Appln. No.: 10/077,898
Amendment dated January 6, 2005
Reply to Office Action of October 6, 2004

Amendments to the Drawings:

FIG.1

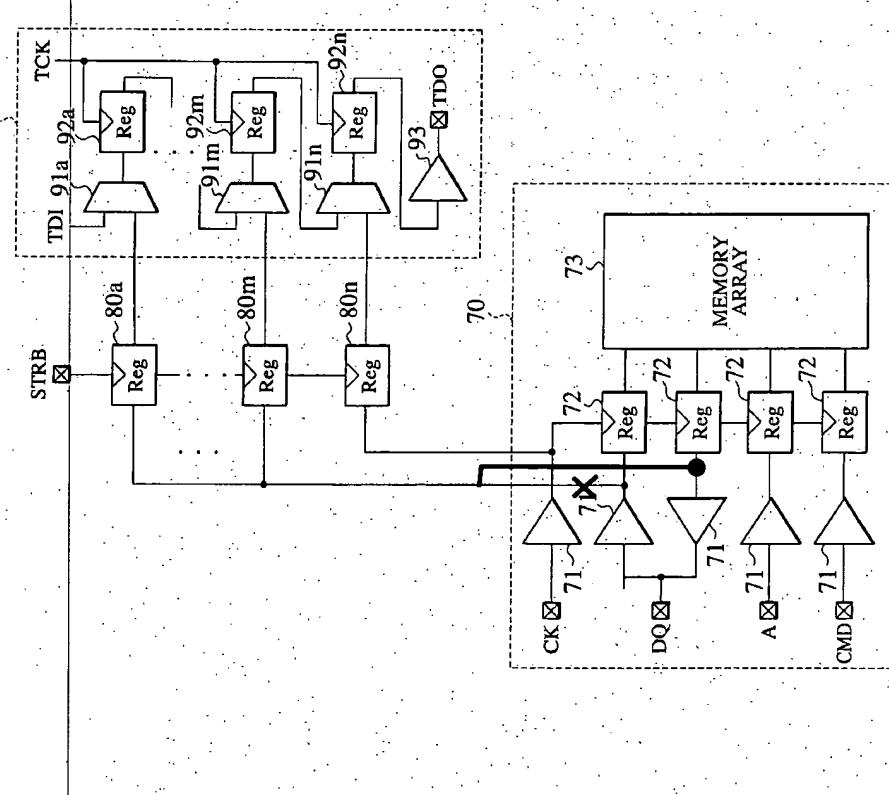
Applicant amends Figure 1 and 3 as shown in the attached marked up version of the drawings and replacements sheets. Figure 1 as originally filed connected the input of register 72 (the top register from memory array 73) in memory core 70 with the input to registers 80a-80m. Figure 3 had a similar connection between the first register 12 in memory core 1 and the inputs to timing test circuits 2a-2i.

These corrections would have been apparent to one of ordinary skill in the art because of the direction of the buffers 71 in order for the registers 80a-80m receive output data from a memory array 73.

Applicant has amended Figure 1 to connect the input of buffer 71 (the third buffer from the top) to the input of registers 80a-80m. Similarly, applicant has amended Figure 3 in a similar fashion.

FIG.3

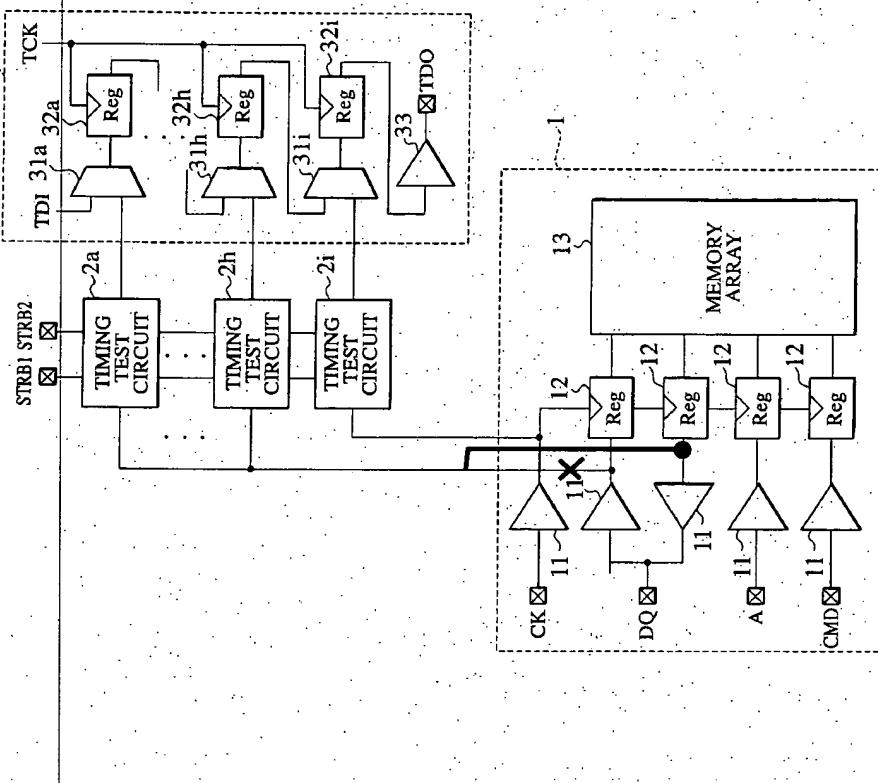
Similarly, the connections in revised Figure 3 as they would have been apparent to one of ordinary skill in the art for the timing test circuits 2a-2h to receive an output from the second register 12 in memory core 1. No new matter has been entered.
